TO: Alex Stone, Transition Project Manager  
Nuclear Waste Program

FROM: Shri Mohan  
Hydrogeologist 3, Nuclear Waste Program

SUBJECT: 300-FF-2 Operable Unit (OU) Uranium Groundwater Contamination

# Well 399-2-2

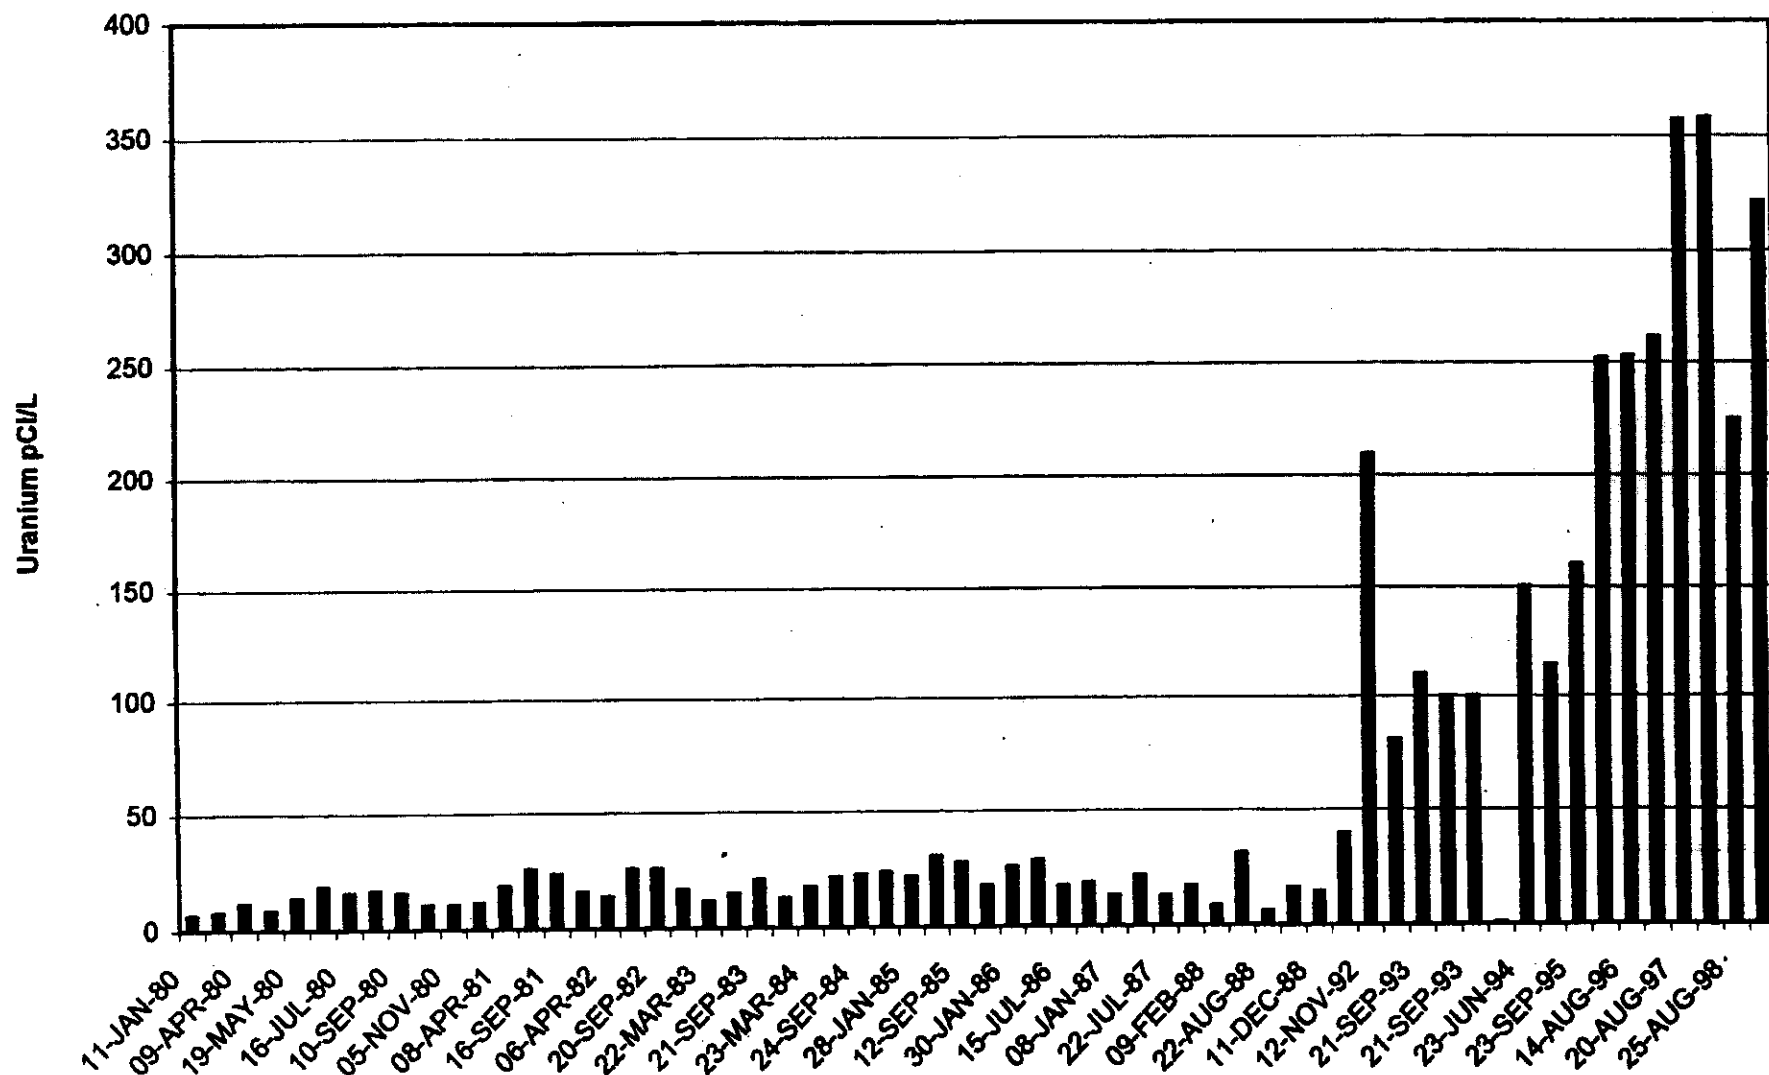
- Wells 399-2-2, 399-2-3, 399-3-1, 399-3-9 and 399-3-10 are located north to south along the river shoreline. The trend plots show gradual increasing uranium concentrations in all these wells. The increasing trend is seen beginning around the year 1990 and has been increasing since. The maximum concentration of uranium in the north most well 399-2-2 is about 350 pCi/L and the southern well 399-3-10 is about 90 pCi/L. All these wells fall within the 300-FF-5 uranium plume. All these wells are very close to the river and it can be easily concluded that the contaminant has been polluting the river for many years.

# Well 399-2-1

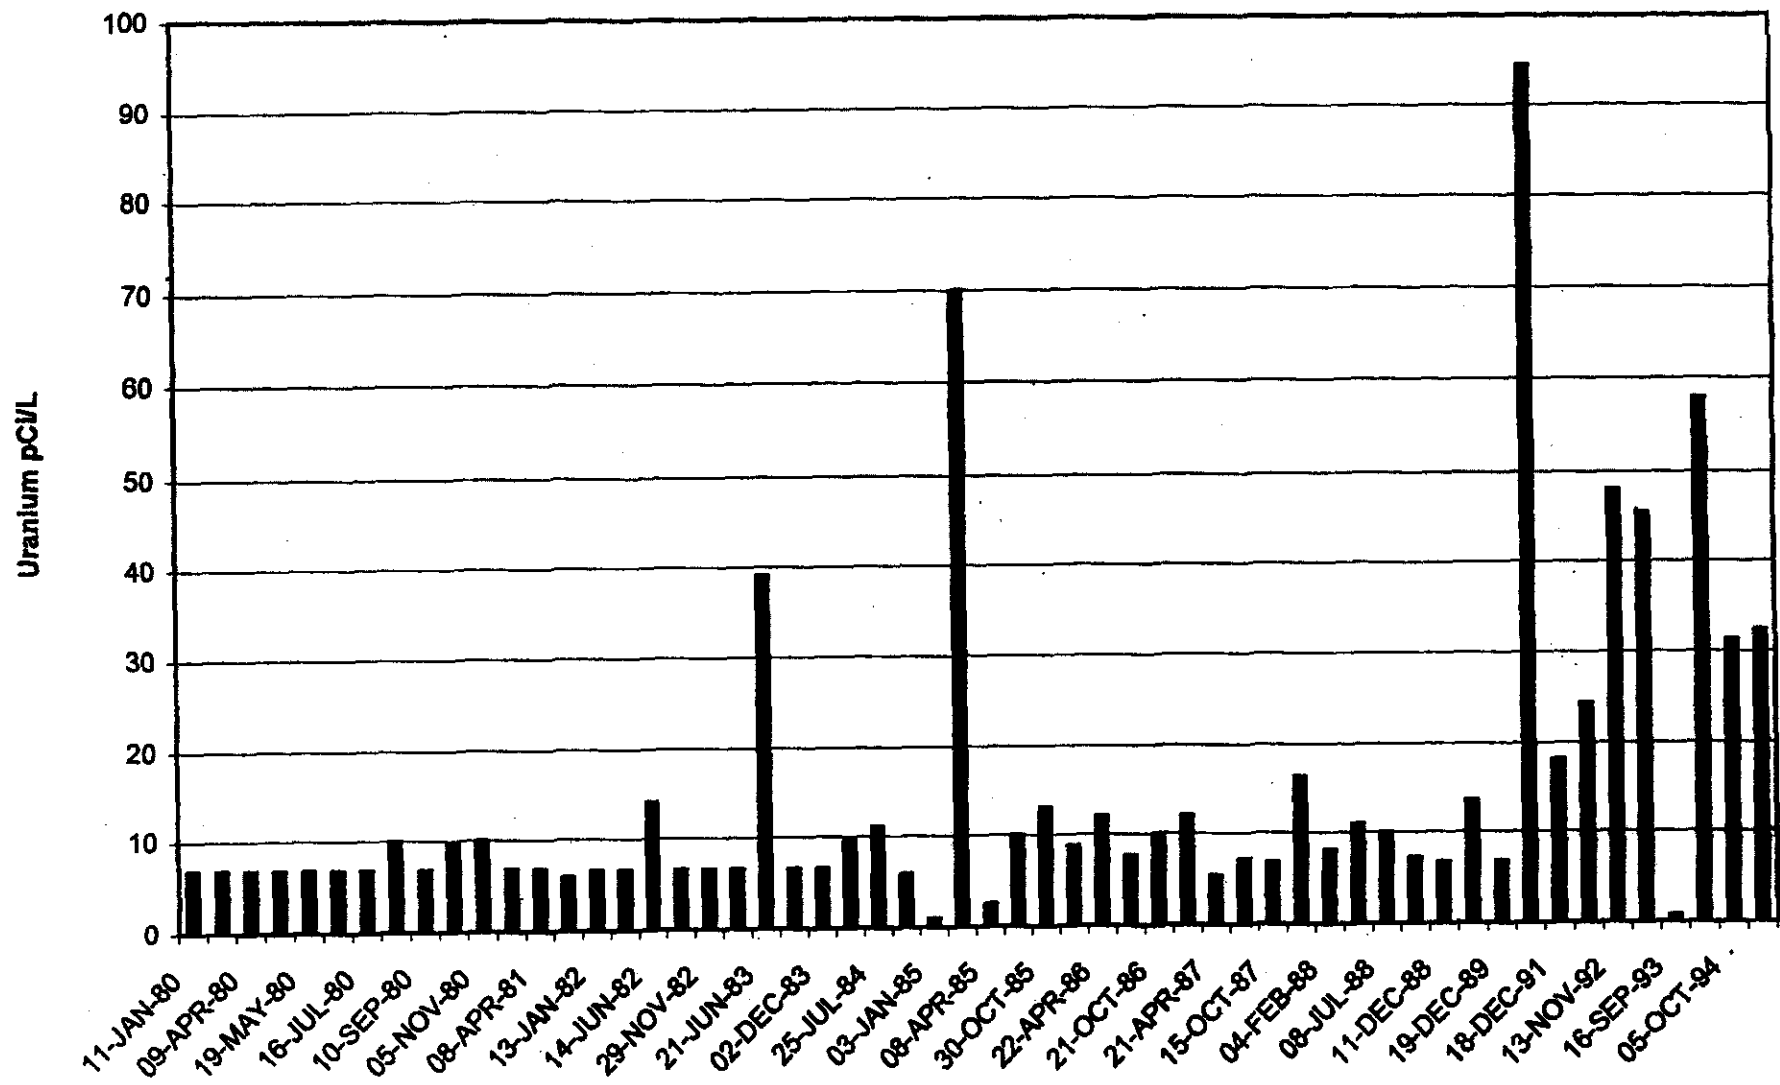
- Uranium concentrations have not decreased as predicted. See plots from wells 399-2-3, 399-2-2, 399-1-5, 399-1-4, 399-3-10, 399-2-1, 399-1-2, 399-3-3, 399-3-2, and 399-3-6.

# Well 399-3-6

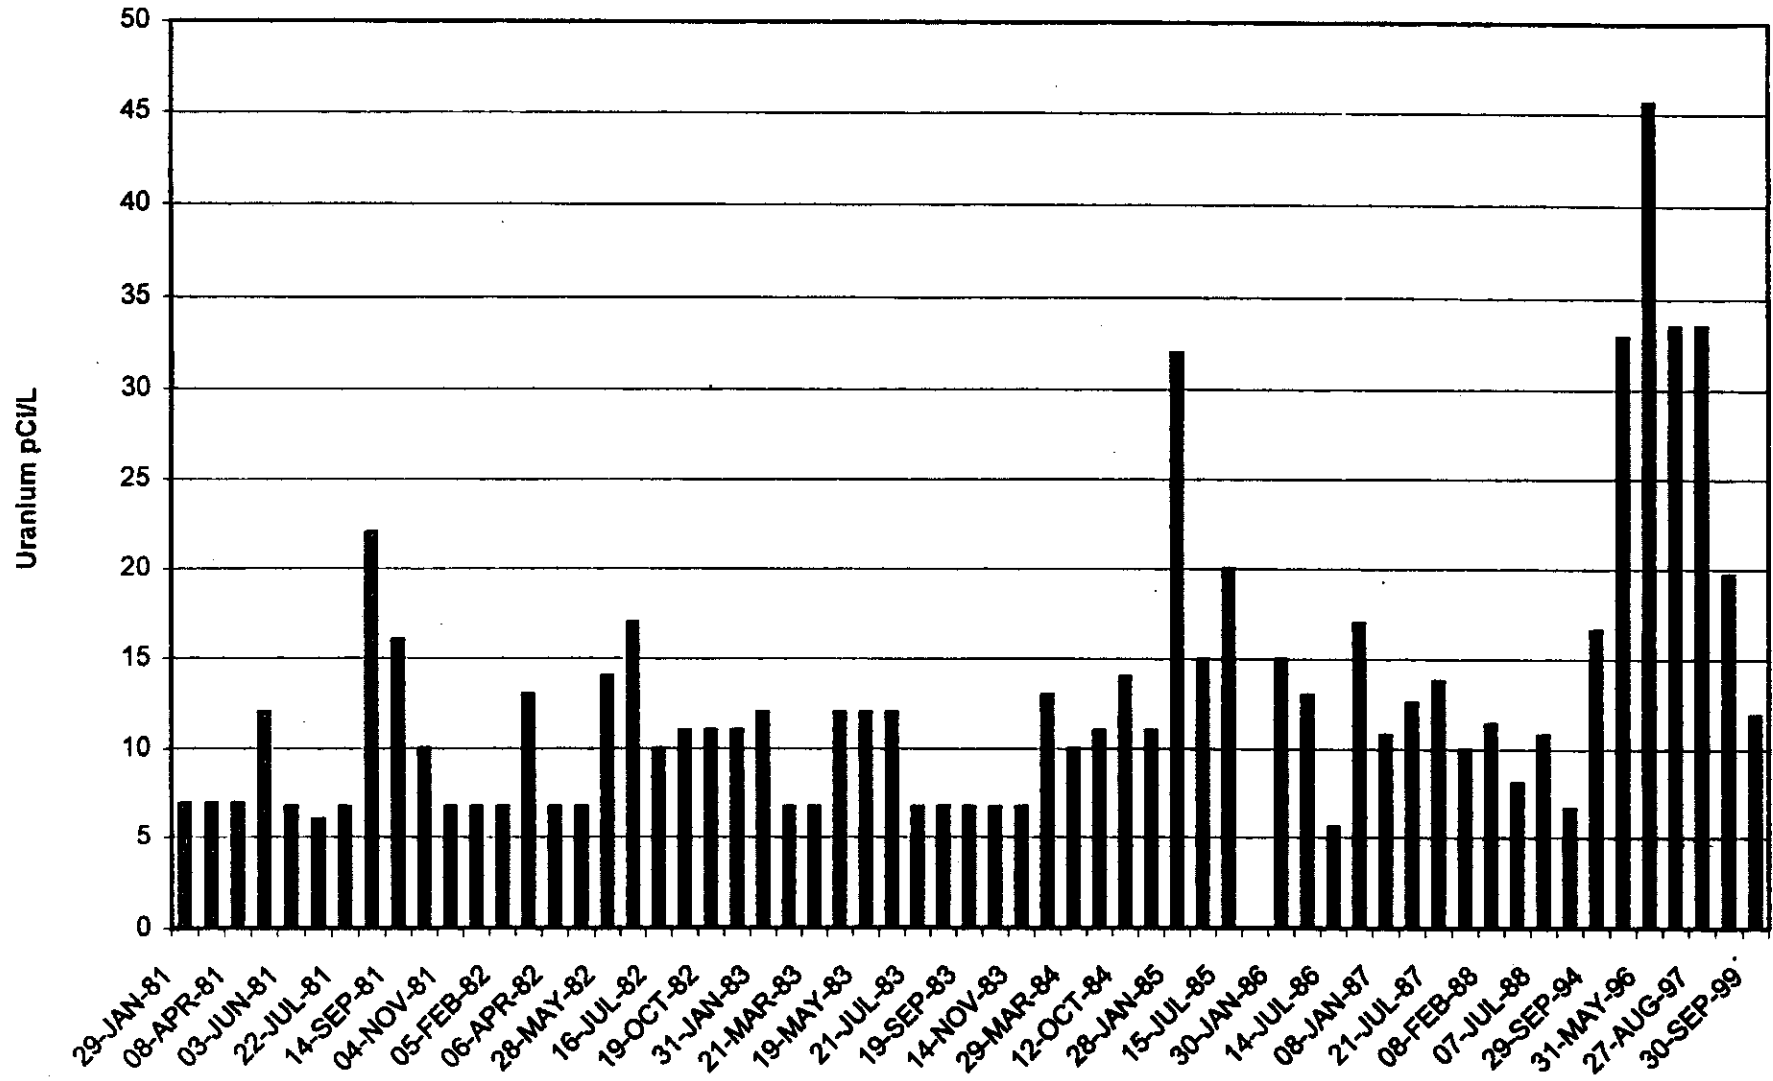
- Wells 399-3-6, 399-3-2 and 399-3-3 are located on the southern part of 300-FF-1 area and are outside the boundary of the uranium plume. There is no specific trend of the uranium concentrations on these wells. However, the concentrations of uranium have been periodically up to approximately 40 pCi/L. Some external source seems to be impacting the uranium concentrations of these wells.

Well 399-1-2

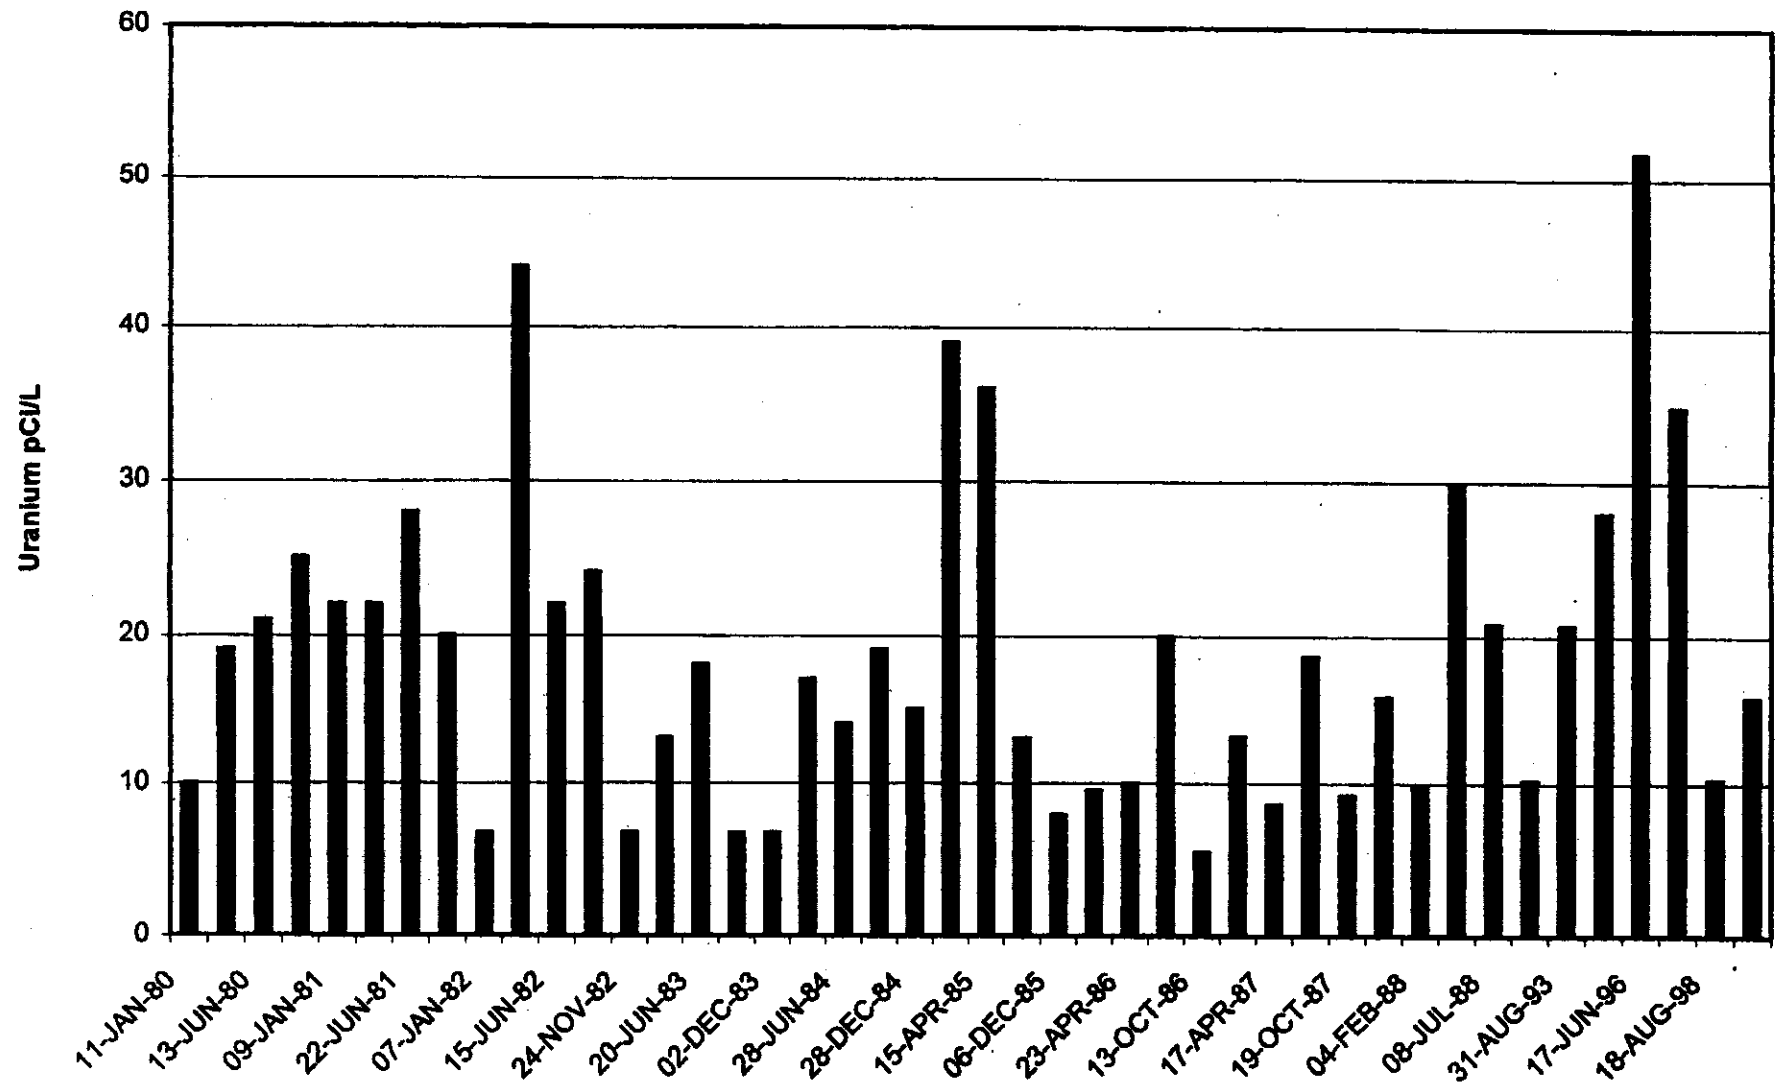
- Wells 399-1-2, 399-1-4 and 399-1-5 have also been plotted for uranium trends. These wells are located within uranium plume and are on the western edged of 300-FF-1 operable unit. Well 399-1-5 shows a definite increasing trend of uranium since about 1992, the maximum concentration being about 180 pCi/L. The other two wells, 399-1-2 and 399-1-4, indicate concentrations in the range of 20 to 50 pCi/L since the beginning of observations. The impact on these wells could be from the source sites in the vicinity of the wells.
